Spokane Park Board

Oct. 12, 2017– 1:30 p.m.

MINUTES

Sheet No.
ASI12-11

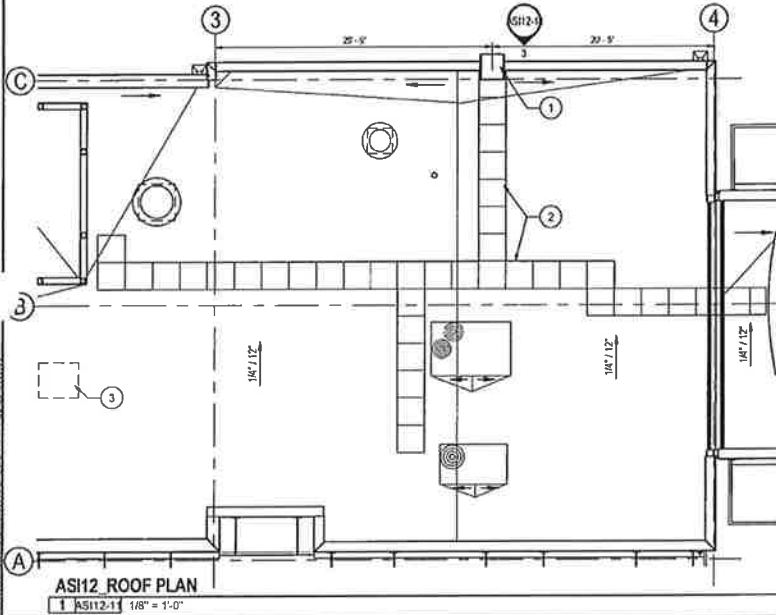
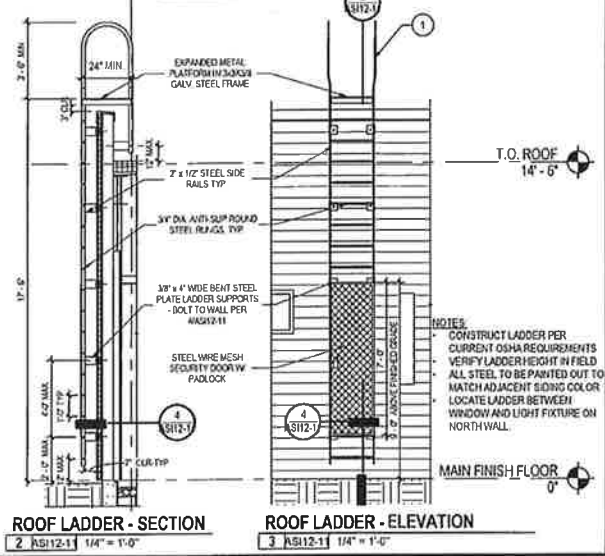
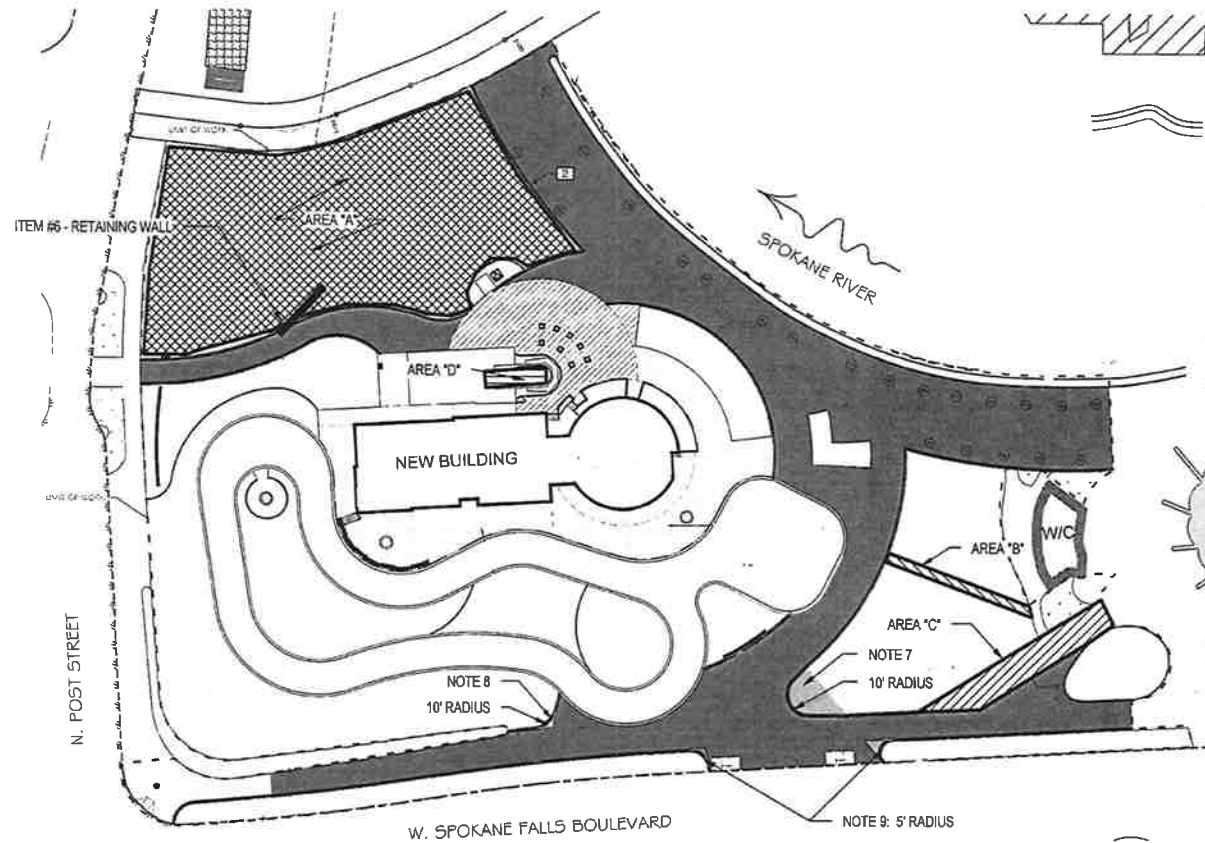
- 1 ADD EXTERIOR FIXED LADDER - GALVANIZED STEEL W/ STEEL MESH SECURITY DOOR - SEE DETAILS
- 2 ADD ROOF PADS FROM FIXED LADDER TO MECHANICAL LOCATIONS
- 3 REMOVE ROOF HATCH, RAILING AND LADDER

- NOTES:
- CONSTRUCT LADDER PER CURRENT OSHA REQUIREMENTS
 - VERIFY LADDER HEIGHT IN FIELD
 - ALL STEEL TO BE PAINTED OUT TO MATCH ADJACENT SIDING COLOR
 - LOCATE LADDER BETWEEN WINDOW AND LIGHT FIXTURE ON NORTH WALL

Title
PR3A - Addendum to PR-3

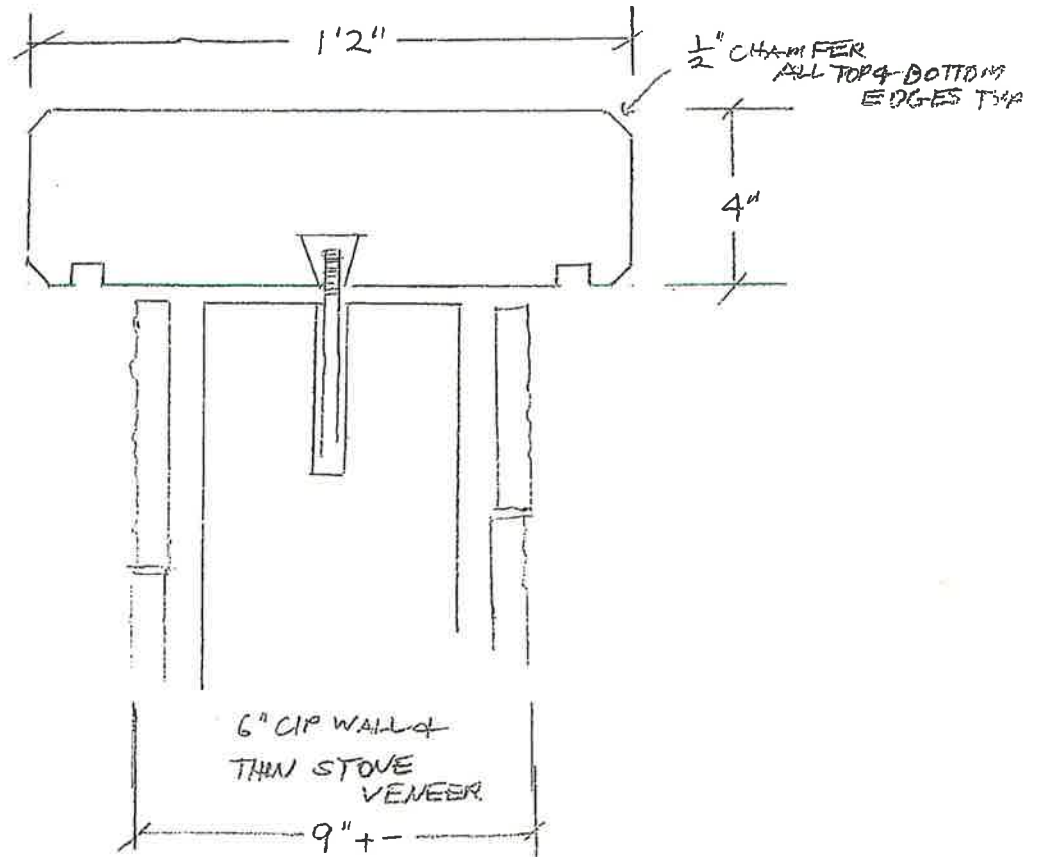
- 1) AREA A (NORTHWEST CORNER OF SITE):
A. CHANGE SOD TO HYDROSEEDING EXCEPT FOR SWALE.
- 2) AREA B (WEST OF FOUNTAIN CAFE):
A. DELETE INDICATED PATH.
- 3) AREA C (SOUTH OF FOUNTAIN CAFE):
A. CHANGE INDICATED PATH FROM CONCRETE TO ASPHALT
- 4) AREA D (UNDER SKYRIDE)
A. ELIMINATE SOD AND IRRIGATION (LEAVE STUB FOR FUTURE - RETAIN AT WEST END FOR REMAINING PLANTINGS) - REPLACE WITH MULCH PER PARK STANDARD.
- 5) GENERAL NOTE:
A. DELETE ALL ANNUAL PLANTS IN CONTRACT. NO REPLACEMENT.
- 6) ADD 12'-4" TO THE RETAINING WALL ON THE NORTH SIDE OF THE NEW WALKWAY (WALKWAY NOT SHOWN IN GRAPHIC). NOTE: GRAPHIC NOT TO SCALE, LOCATION SHOWN IS APPROXIMATE.
- 7) EXTEND GRASS AREA AND PROVIDE 10' RADIUS TO HARDSCAPE AT LOCATION INDICATED IN GRAPHIC.
- 8) PROVIDE 10' RADIUS TO HARDSCAPE AT LOCATION INDICATED IN GRAPHIC.
- 9) PROVIDE 5' RADIUS TO HARDSCAPE AT 2 LOCATIONS INDICATED IN GRAPHIC.

RIVERFRONT PARK -
REVISED BENCH SHAPE
% SPILTER PRECAST

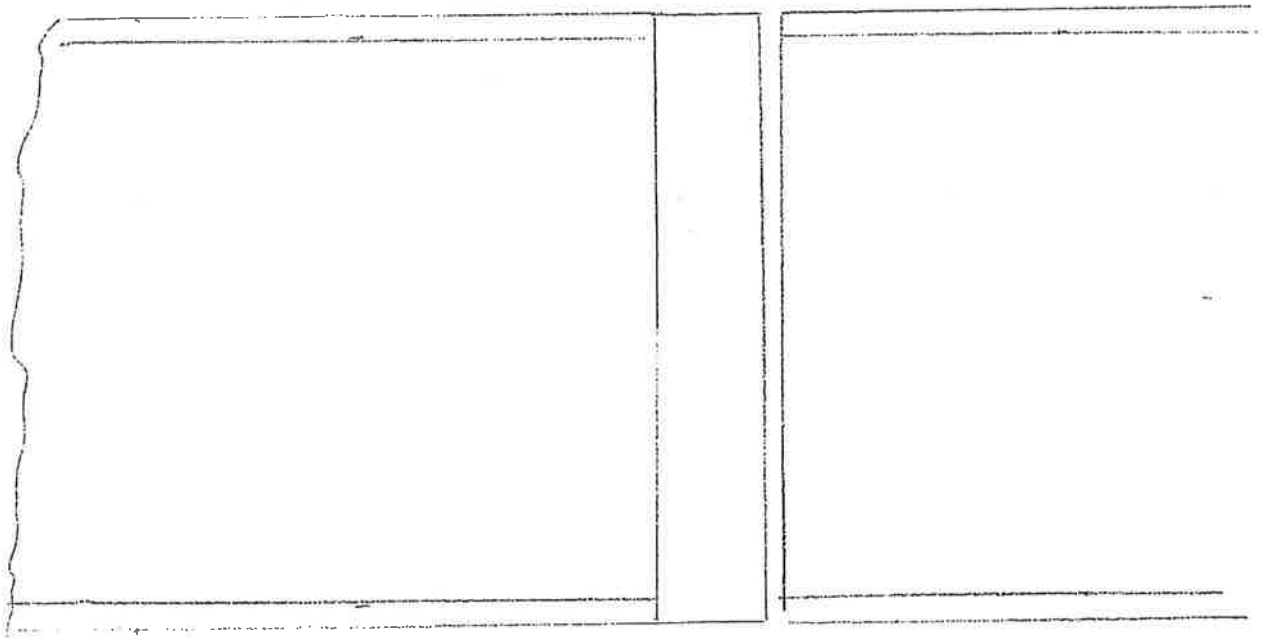
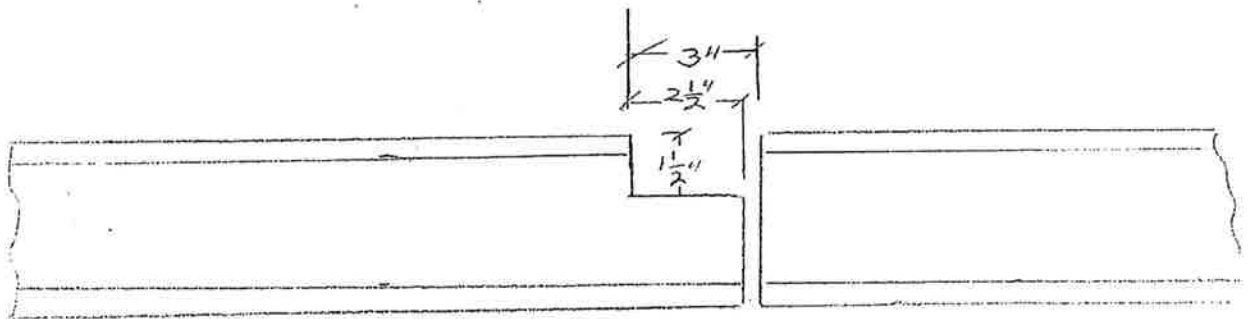
Attached is a breakdown of additional labor and material costs for natural stone veneer and the new precast cap final design. Pricing does not include staining or coloring of the precast caps. Once we receive a change order for this additional cost, we will place an order for the materials.
